M E M O

To: Mike Zimmerman, Everglades National Park

Subject: C111 - GRR Supplement

S331 Phosphorus Data

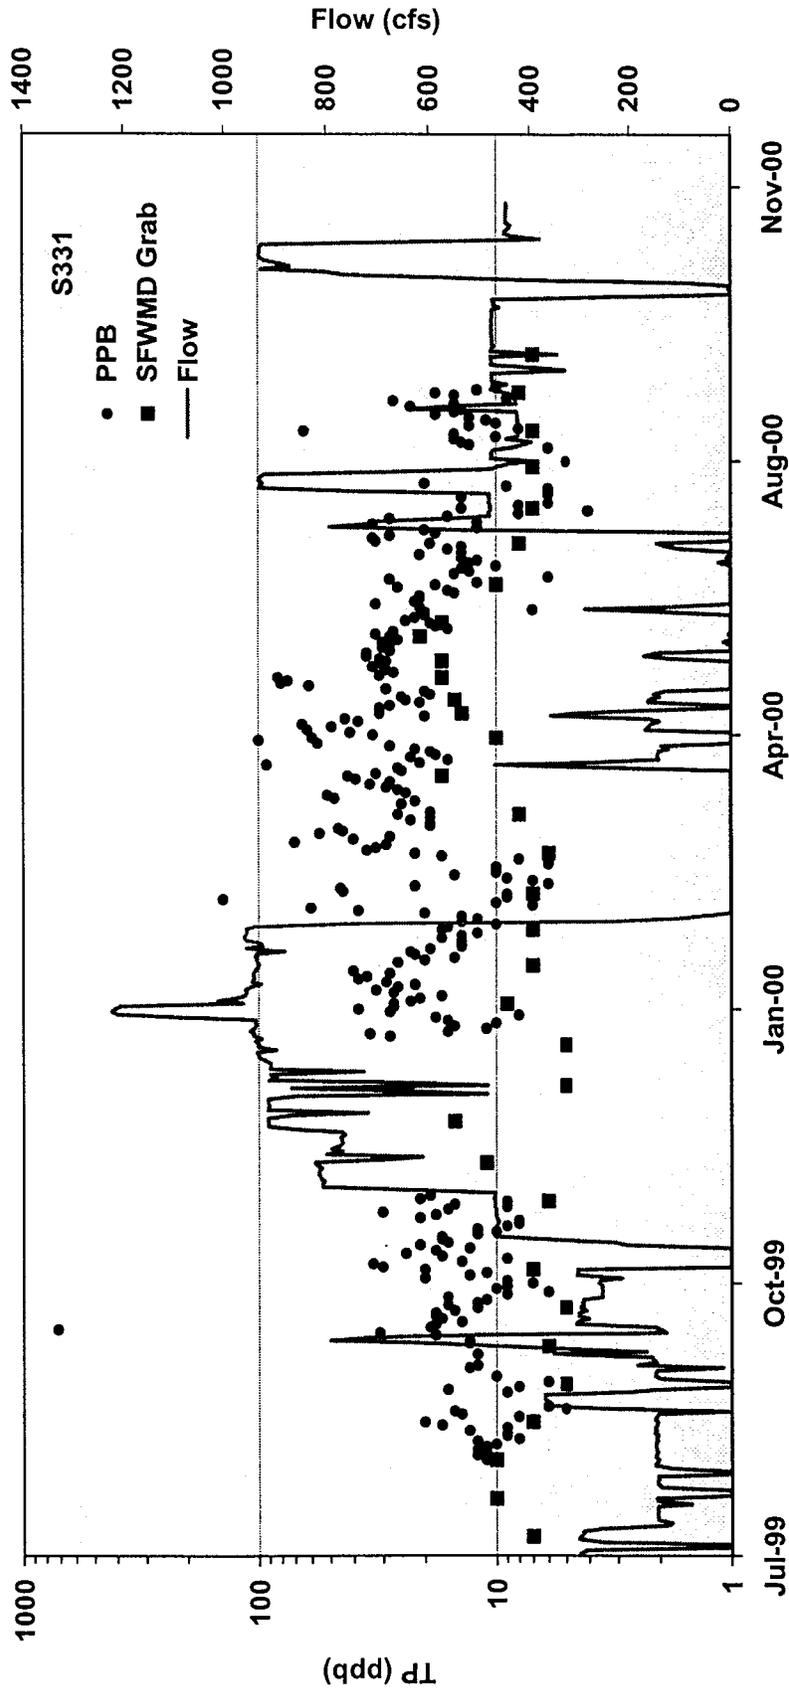
Evaluation of potential water quality problems is hindered by discrepancies in the phosphorus data. These discrepancies are obvious in the attached graphs of data from S331, S332D, and S332. Processes to resolve these problems are reportedly underway. Despite considerable efforts under the Everglades Round Robin program, data incompatibility across labs continues to be a significant problem in attempting to integrate monitoring and research results, particularly in these low concentration ranges. To minimize these problems in the future, I recommend that all monitoring be conducted by SFWMD under an appropriate cost-sharing agreement. Since buffer cell sizes are determined by land constraints (vs. an engineering calculation based upon loads), data uncertainties do not seem to be on the critical path of this project at this point. Resolution of these matters should be a TOC priority.
